Document 00910

ADDENDUM NO. Date of Addendum: \(\square\frac{\pi_{\infty}}{20} \)

PROJECT NAME: Almeda Road Paving and Drainage Improvements Old Spanish Trail to South MacGregor Way PROJECT NO: WBS No. N-000806-0001-4; CSJ No. 0912-72-072 BID DATE: May 28, 2015 J. Timothy Lincoln, P.E., City Engineer FROM:

TO: **Prospective Bidders**

THUSITHA SILVA 82988

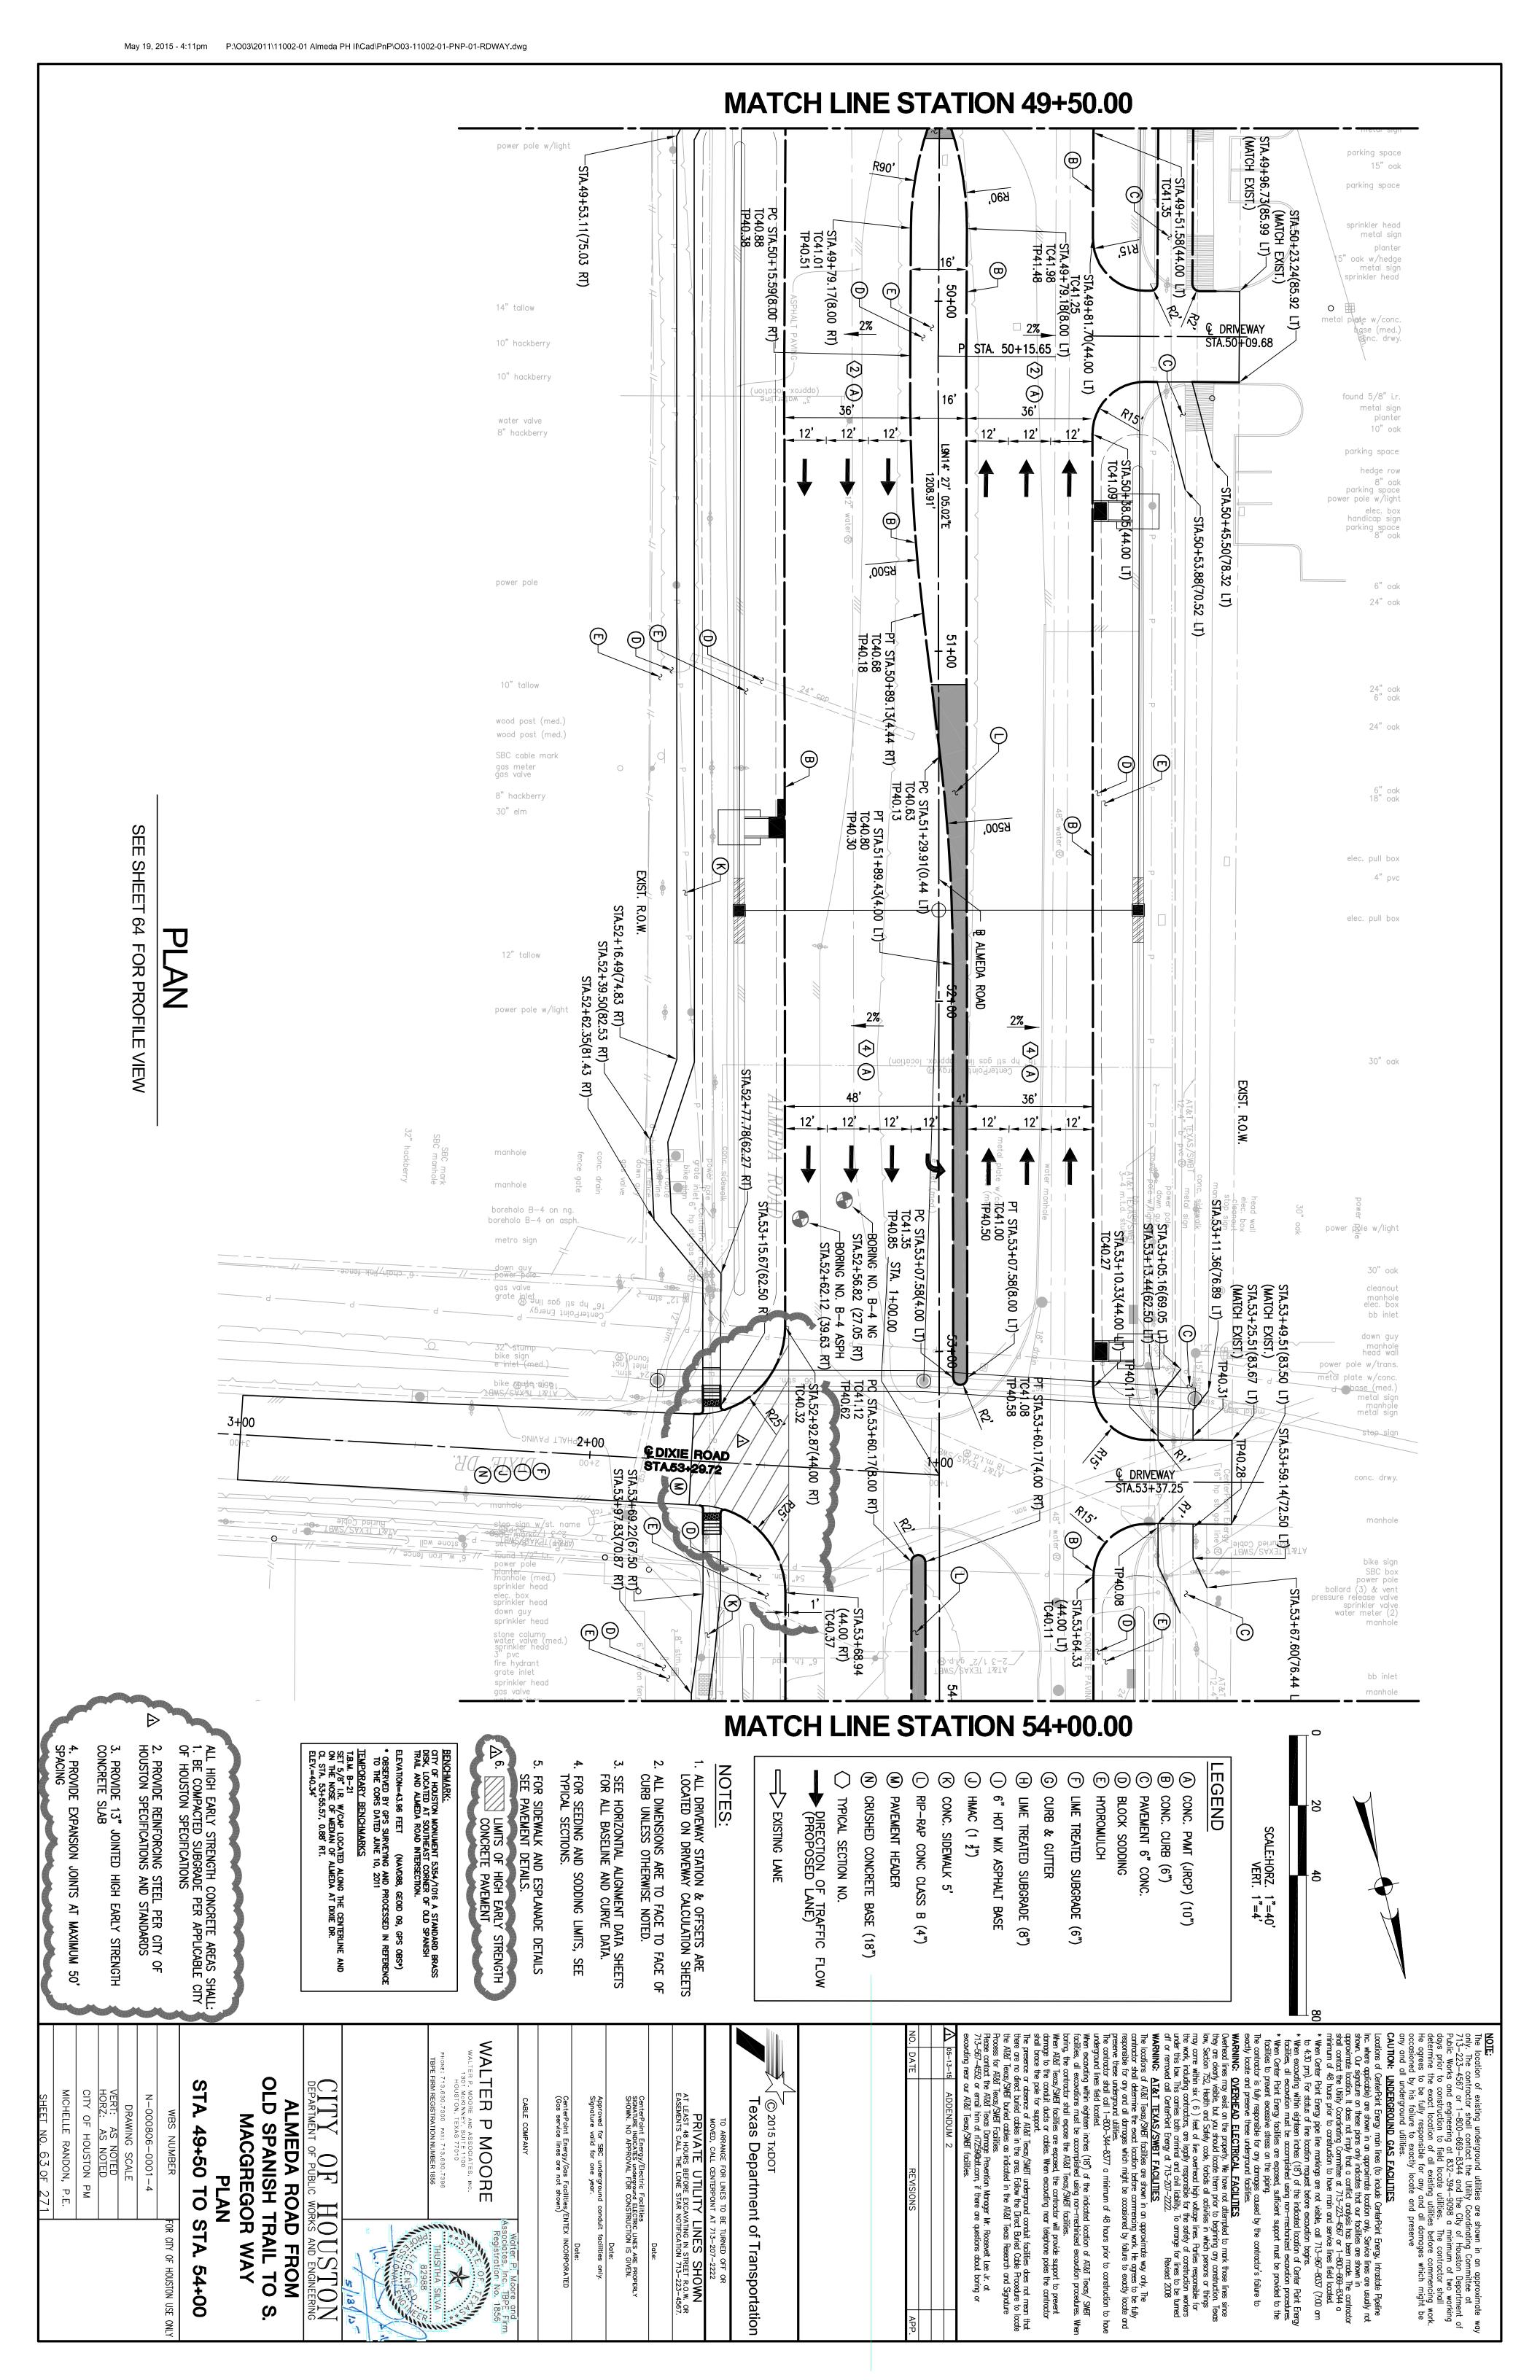
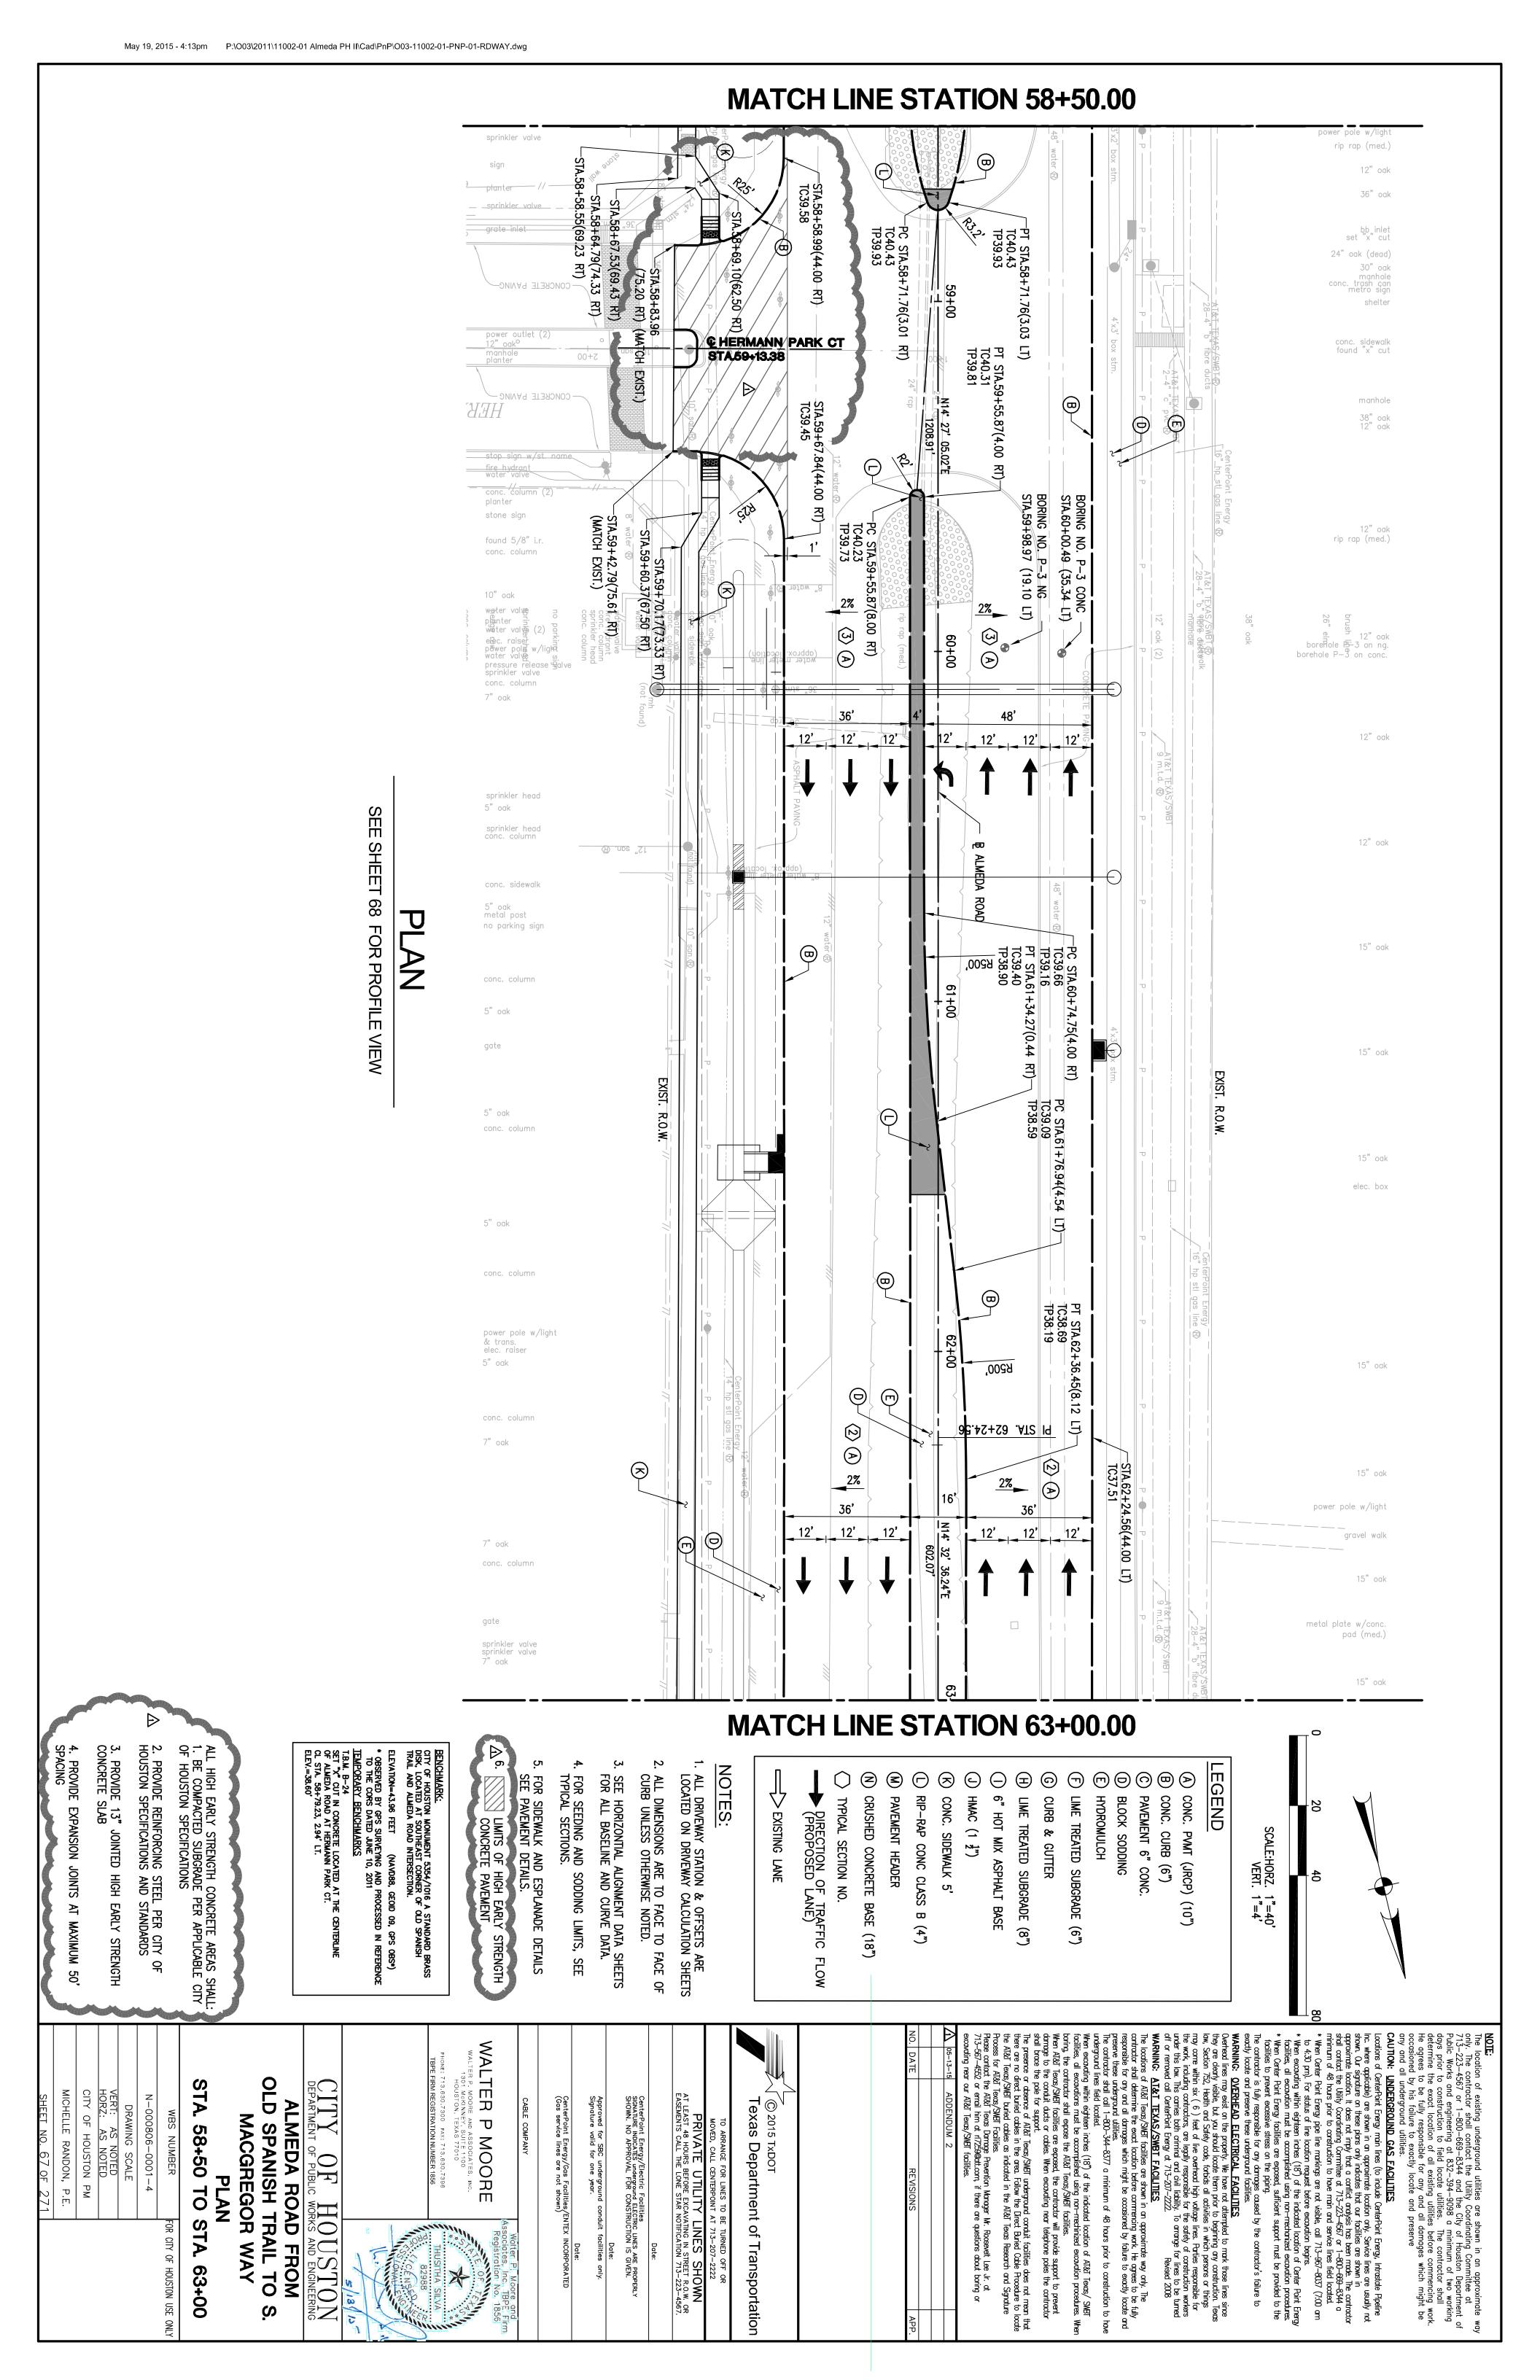
- 1. Sheet 21- Revised Holcombe Boulevard typical section, STA 6+37.98 to END PROJECT, to reflect added pavement and sidewalk reconstruction.
- 2. Sheet 22 Revised DEMOLITION QUANTITY.
- Sheet 22 A Revised STORM SEWER & STREET & BRIDGE QUANTITY
- 4. Sheet 47 Added driveway at station 16+04.59 & added shaded area to reflect limits of High Early Strength Concrete placement limits.
